SECTION J PART J4 PERFORMANCE-BASED DESIGN BRIEF (PBDB)

OPAL BAYVIEW GARDENS RACF

DOCUMENT No.: 240516
DOCUMENT TITLE: Opal Bayview RACF
NCC 2022 Section J Building Fabric Requirements
DOCUMENT REV: D
DOCUMENT BY: J.B DATE: 04/08/2025

A100 BASEMENT
SCALE: 1:200
0 5.0M 10.0M

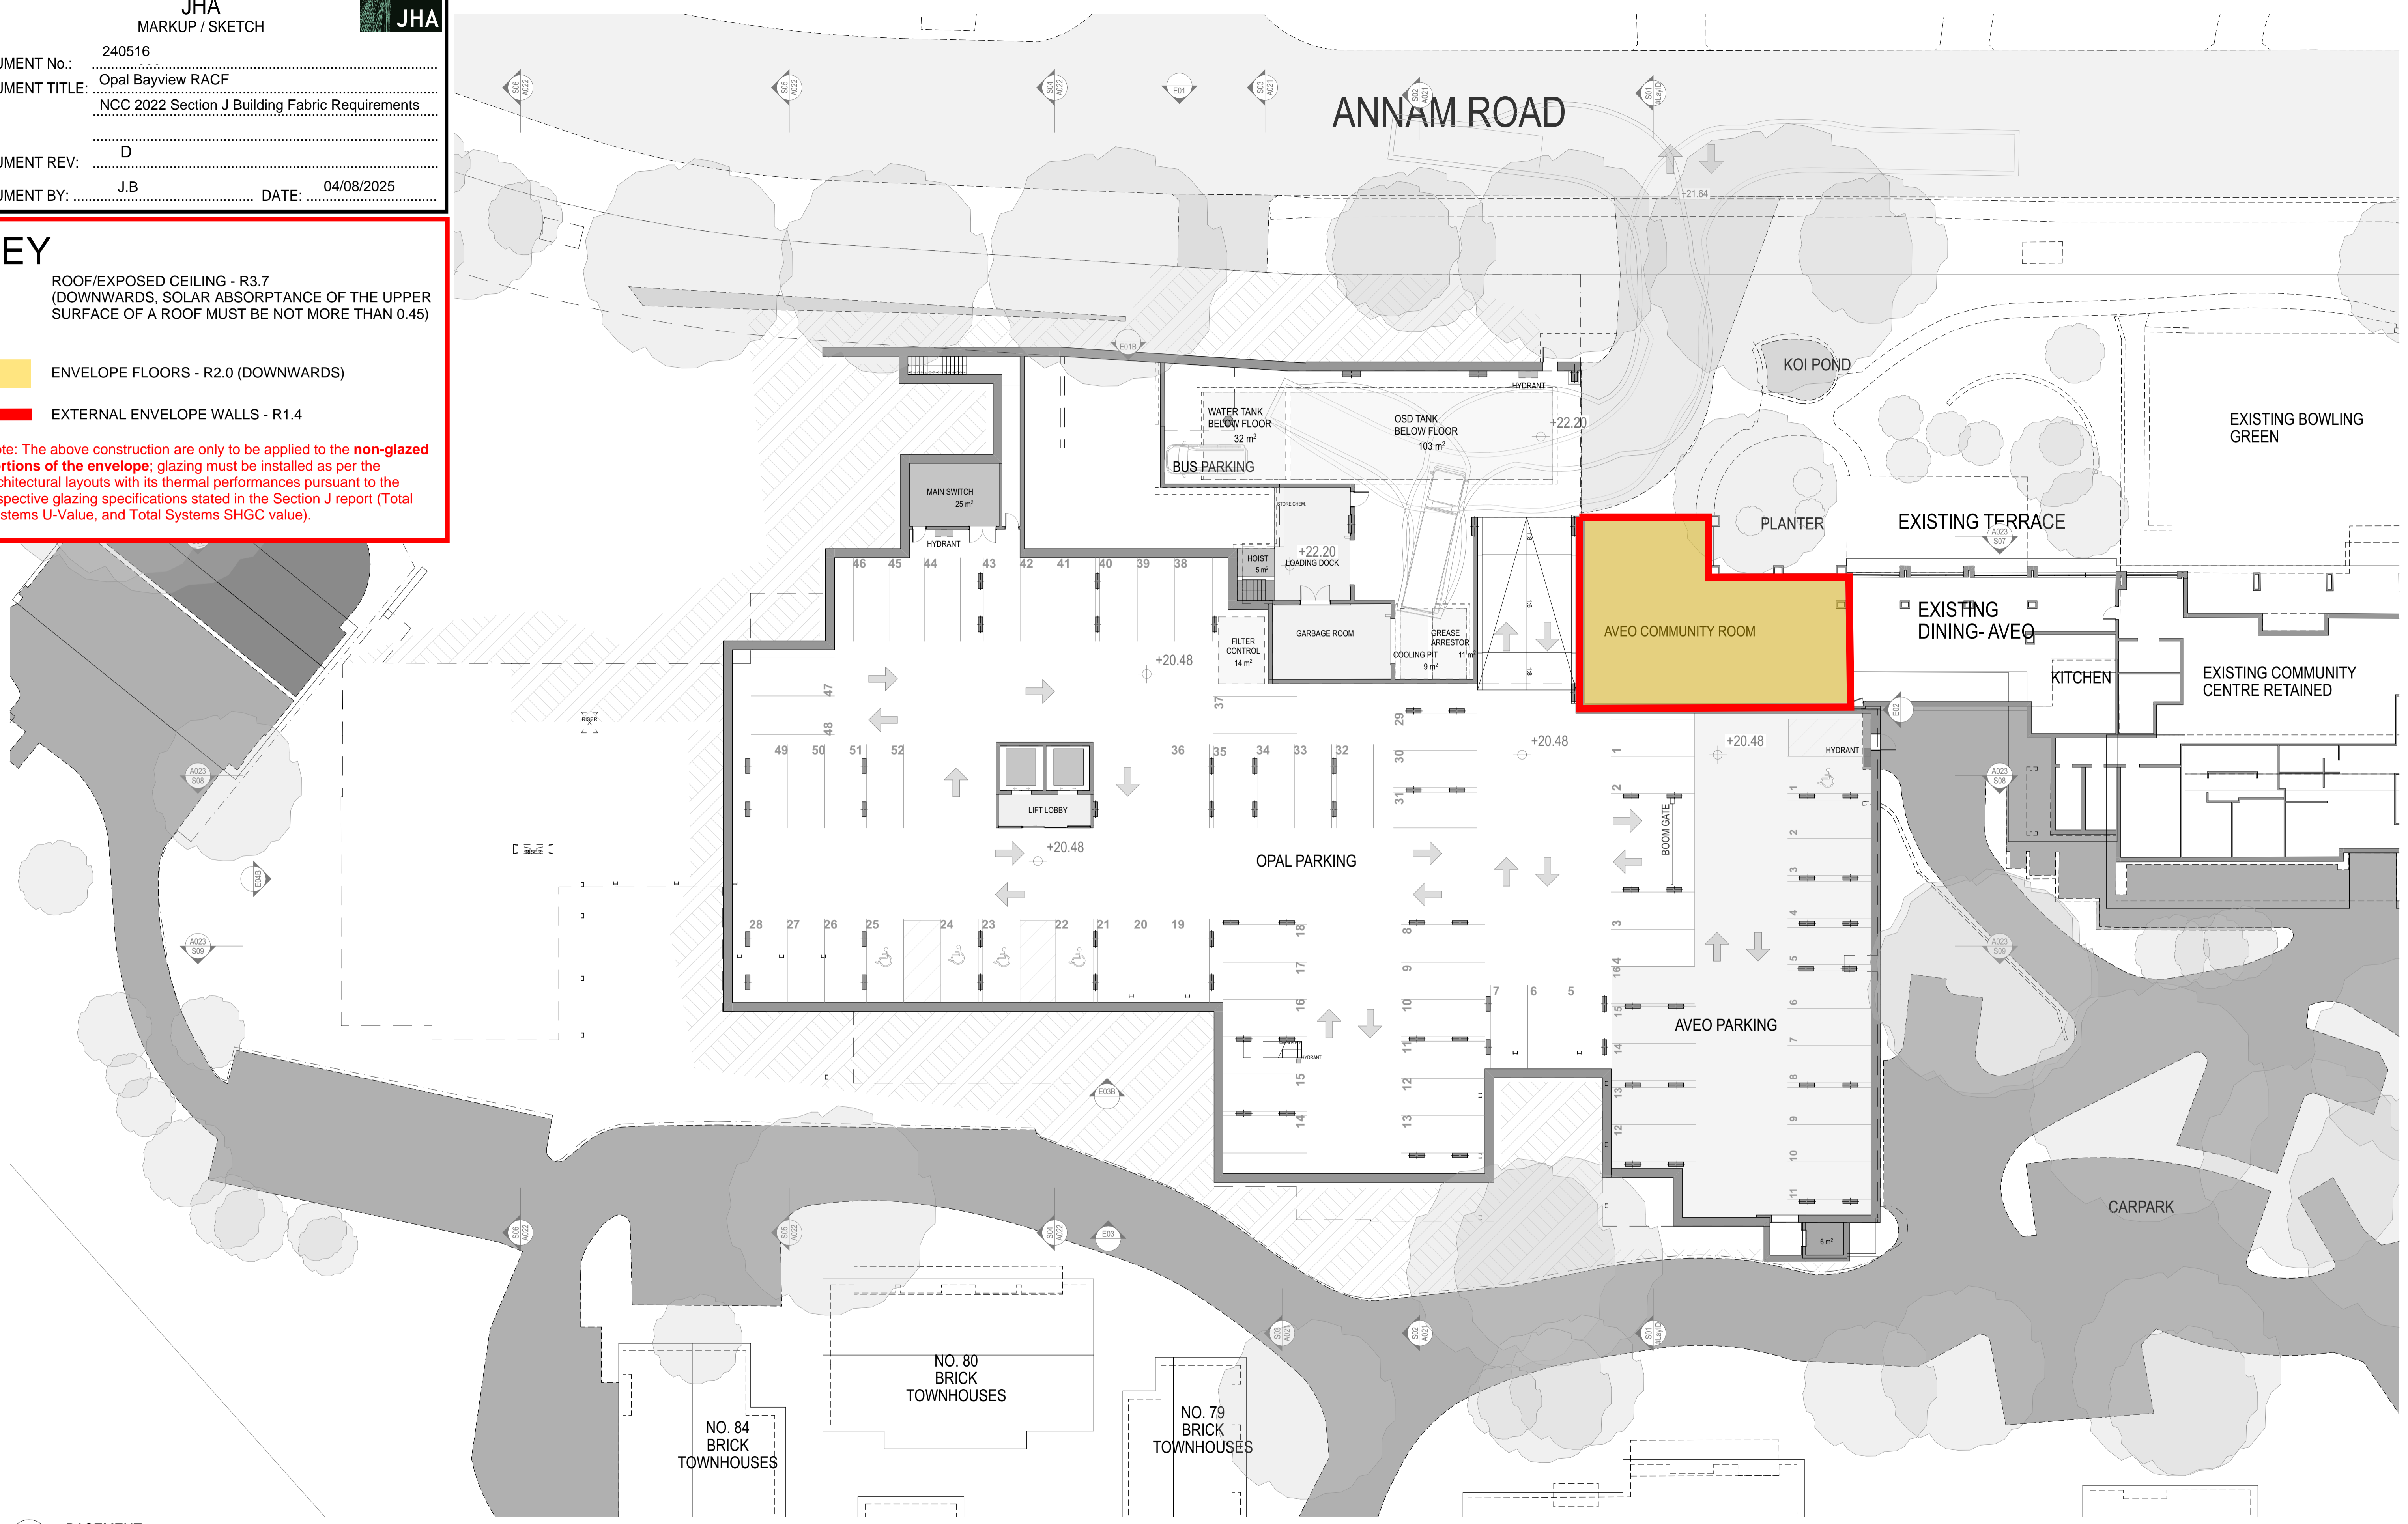
KEY
ROOF/EXPOSED CEILING - R3.7
(DOWNWARDS, SOLAR ABSORPTANCE OF THE UPPER SURFACE OF A ROOF MUST BE NOT MORE THAN 0.45)
ENVELOPE FLOORS - R2.0 (DOWNWARDS)
EXTERNAL ENVELOPE WALLS - R1.4
Note: The above construction are only to be applied to the non-glazed portions of the envelope; glazing must be installed as per the architectural layouts with its thermal performances pursuant to the respective glazing specifications stated in the Section J report (Total Systems U-Value, and Total Systems SHGC value).

A101 LOWER GROUND FLOOR
SCALE: 1:200

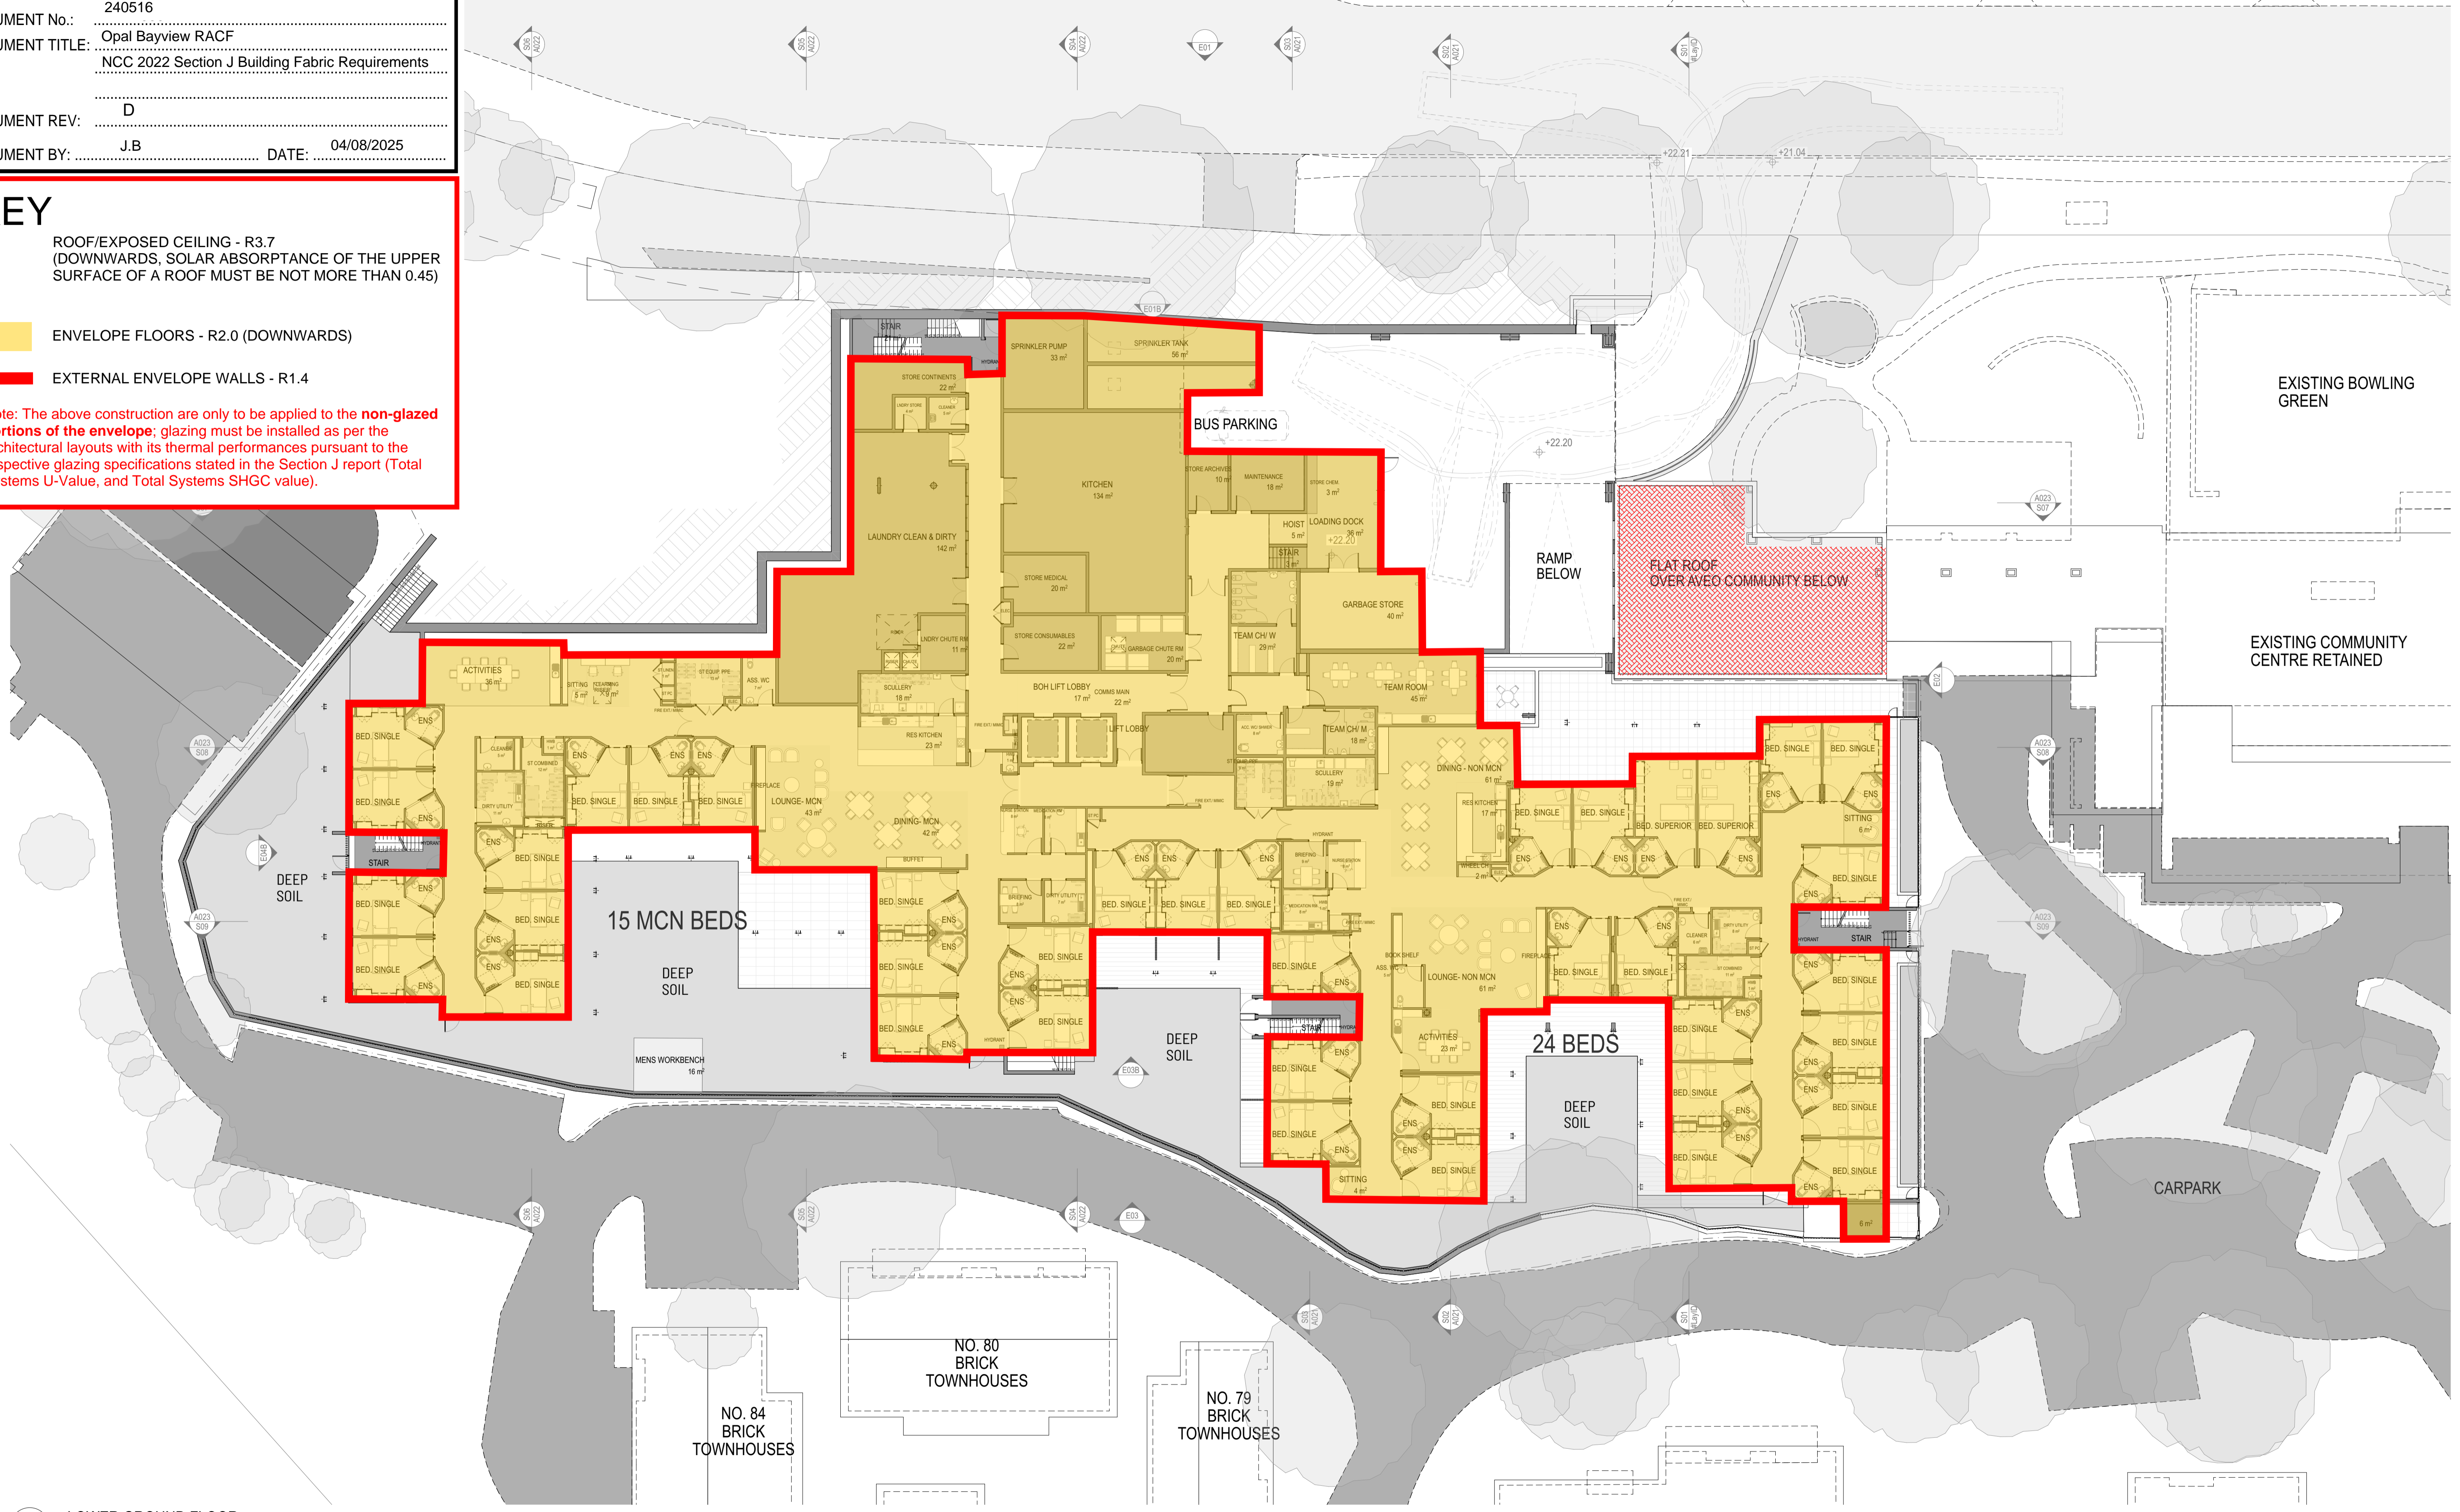
ROOF/EXPOSED CEILING - R3.7
(DOWNWARDS, SOLAR ABSORPTANCE OF THE UPPER SURFACE OF A ROOF MUST BE NOT MORE THAN 0.45)

ENVELOPE FLOORS - R2.0 (DOWNWARDS)

EXTERNAL ENVELOPE WALLS - R1.4

Note: The above construction are only to be applied to the **non-glazed portions of the envelope**; glazing must be installed as per the architectural layouts with its thermal performances pursuant to the respective glazing specifications stated in the Section J report (Total Systems U-Value, and Total Systems SHGC value).
